Subject: Supplement No. 1
Geotechnical and Geologic Investigation
Lots 11, 19, and 20, Block 15, Tract No. 7803
1749 and 1751 Malcolm Avenue and 1772 Glendon Avenue
Los Angeles, California

We are pleased to submit this Supplement No. 1 report responding to the City comments. The original report of geotechnical and geological investigation report for the subject project was issued by this office on July 21, 2015.

This submittal is in response to comments in a Geology and Soils Report Correction Letter dated August 19, 2015 by the Grading Section Of the Department of Building and Safety of the City of Los Angeles (Log # 89430). For convenience, we have enclosed a copy of the City Review Letter with this Supplement No. 1 report. Our responses also incorporate verbal discussion of the comments between the undersigned geologist and Mr. Schneidereit of LADBS as well as with Mr. Brian Olson of the California Geologic Survey.

GEOLOGIC CROSS SECTION F-F'

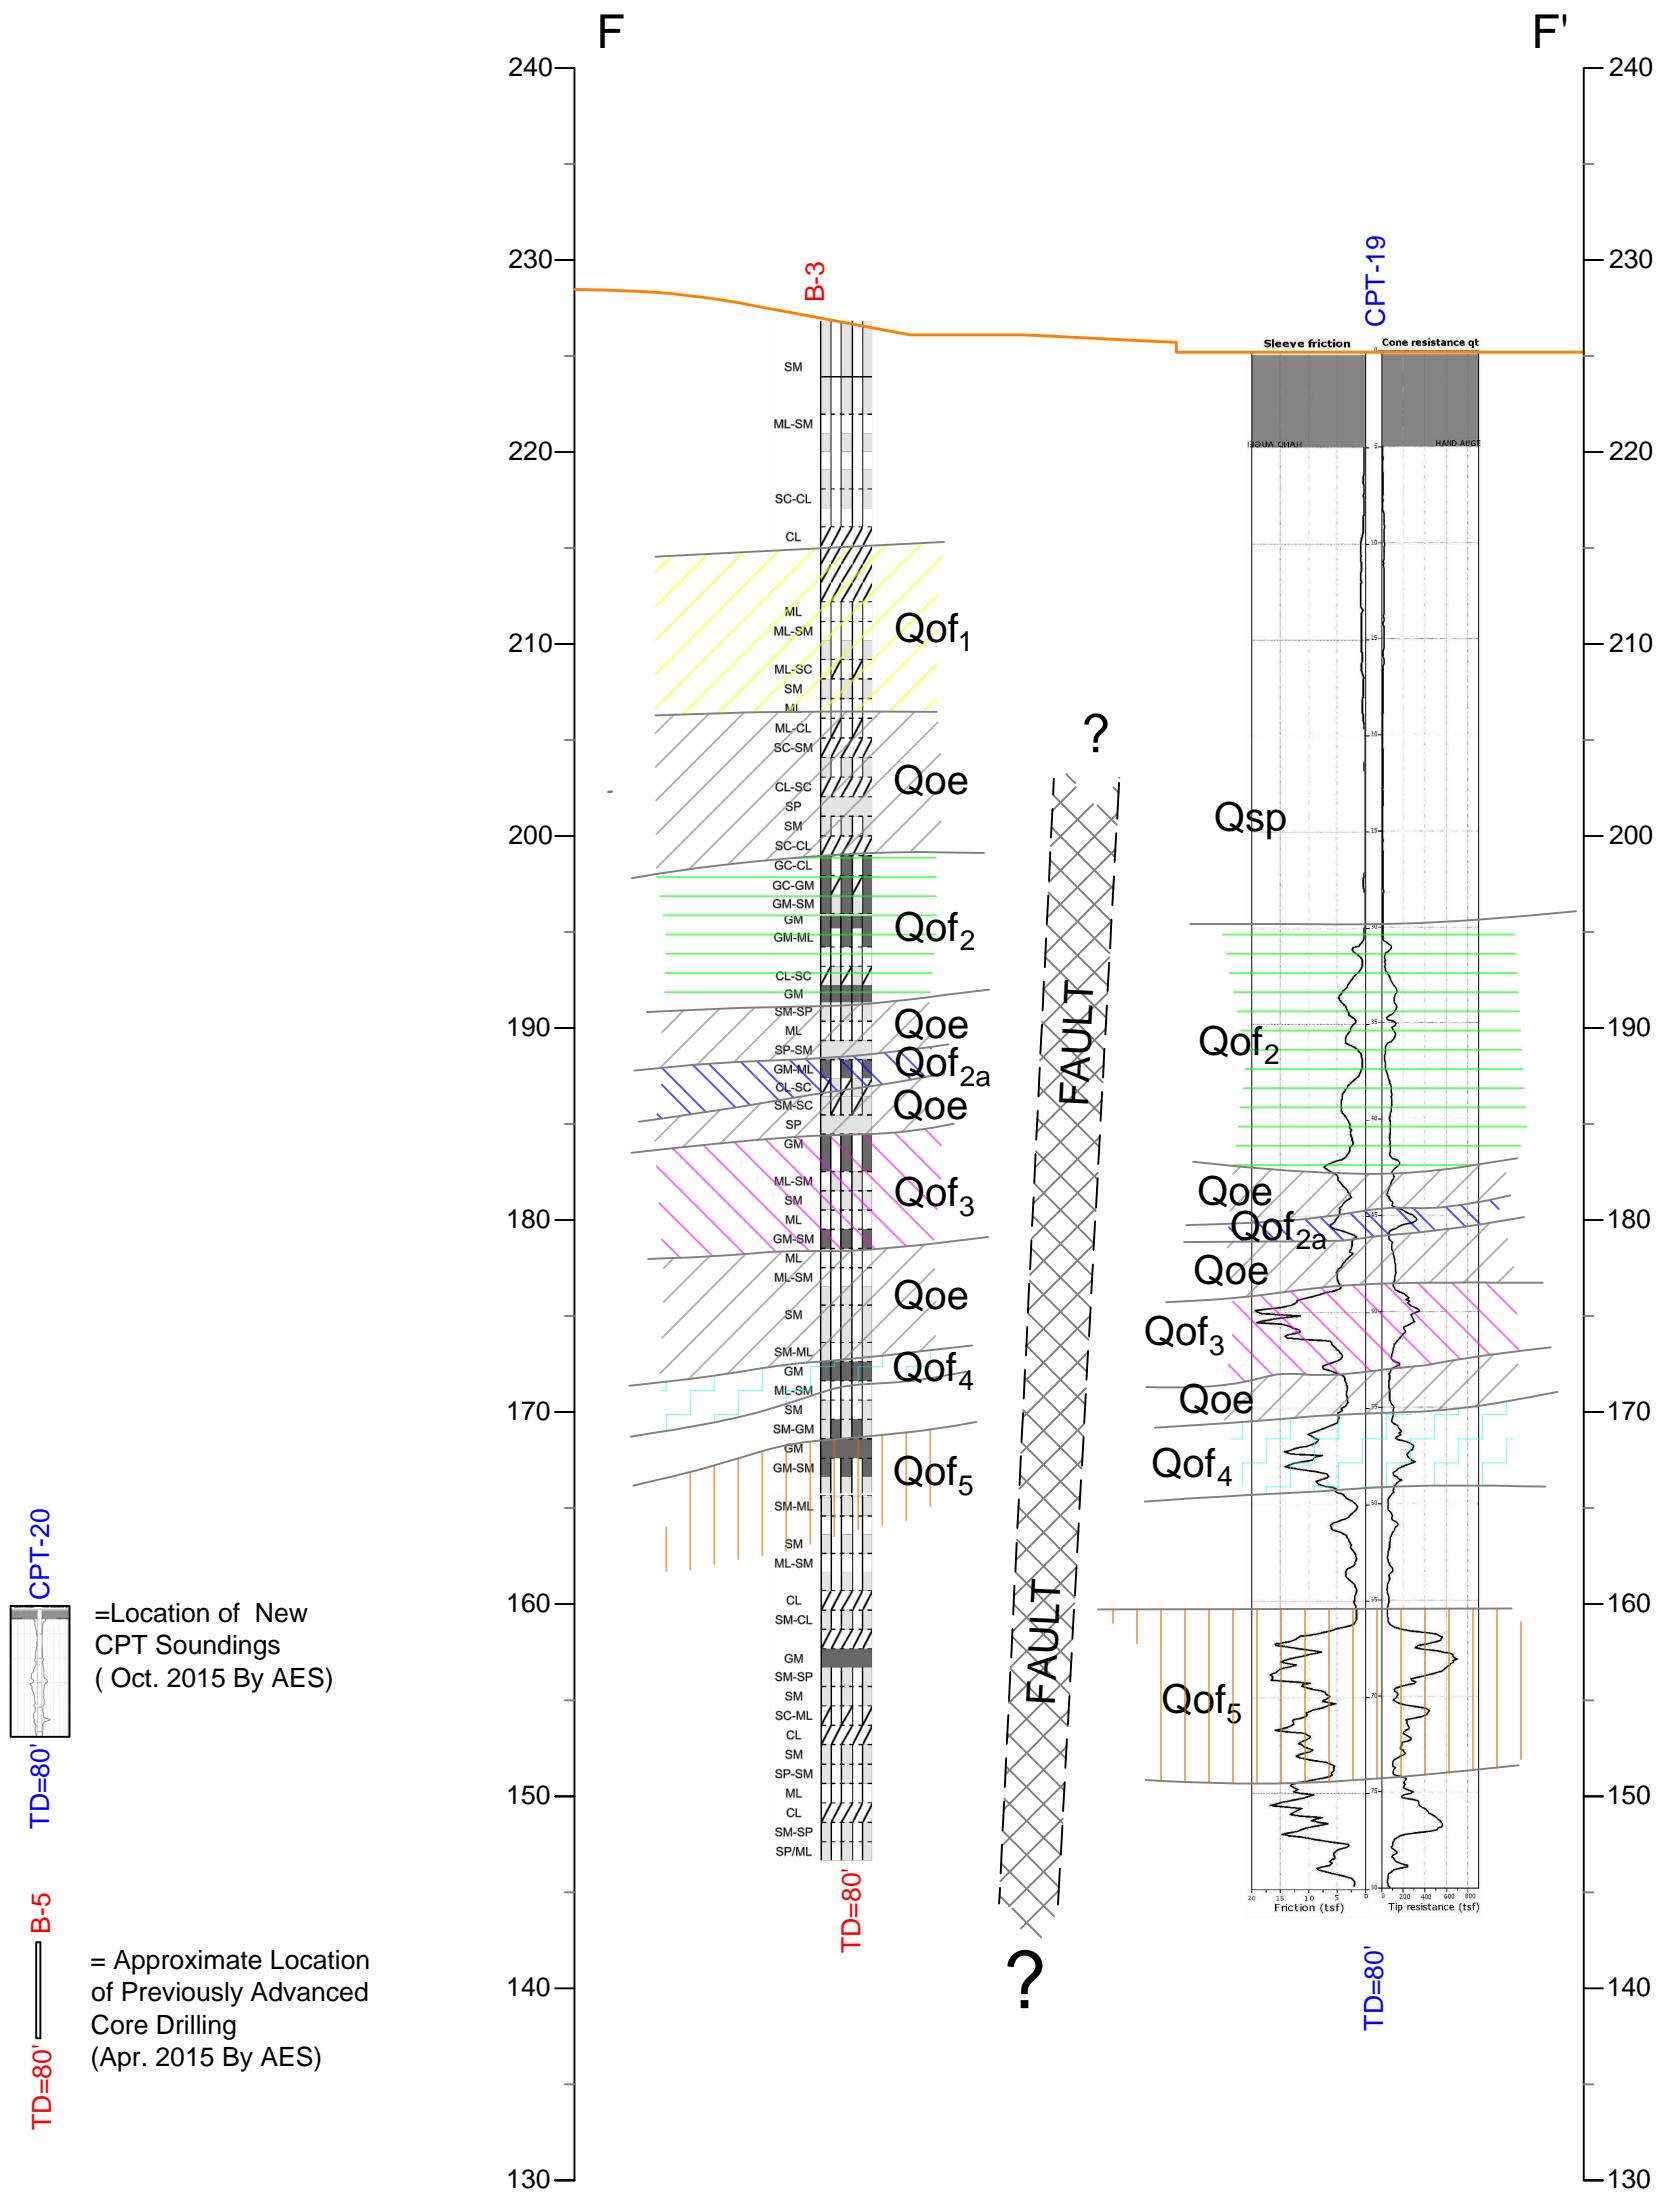
1. The proposed 10-ft. setback from the active fault splay appears small given that the fault was identified at only one location and there is no direct evidence of the orientation of the fault. In addition, the fault trace may be closer to B-3 than estimated. Additional exploration is required to determine the fault's trend in at least two locations to warrant the recommended reduced setback. Alternatively, a larger setback could be recommended.
2. Provide more detailed discussion on the stratigraphic correlation from CPT-13 to B-3. The upper soils of CPT-11 to CPT-13 appear more fine-grained than the soils observed from CPT1 and B-1. It seems like Qof-1 is missing from CPT-2 (back to fine-grained) and the top of Qof-2 appears to be lower.
3. What is the purple marker bed shown at depth on the northern portion of Cross Section A-A'.

In order to determine this, we have included new short geologic sections C, D, E, F and G which are extended subparallel to the fault trace, between CPTs and borings on private property and CPTs on the street. These additional sections serve to present positive cross-correlation (or lack thereof) of subsurface geology between the two main north-south transects. Subsurface profiles as depicted in sections C and D, which are south of the fault, appear to match up reasonably well at the same or similar elevations. Section E, which extends parallel and just north of the mapped fault, also matches subsurface layers reasonably well. However, in sections F (between CPT 19 and B-3) and G (between CPT-6 and

CPT-19), both of which cross the projected fault, subsurface layers appears to be disrupted or disturbed. Our interpretation of the subsurface structure essentially locks in the orientation of the fault from the street to the east portion of the property, and this orientation is essentially the same as what was previously reported. Please see attached Drawings for graphical depiction.
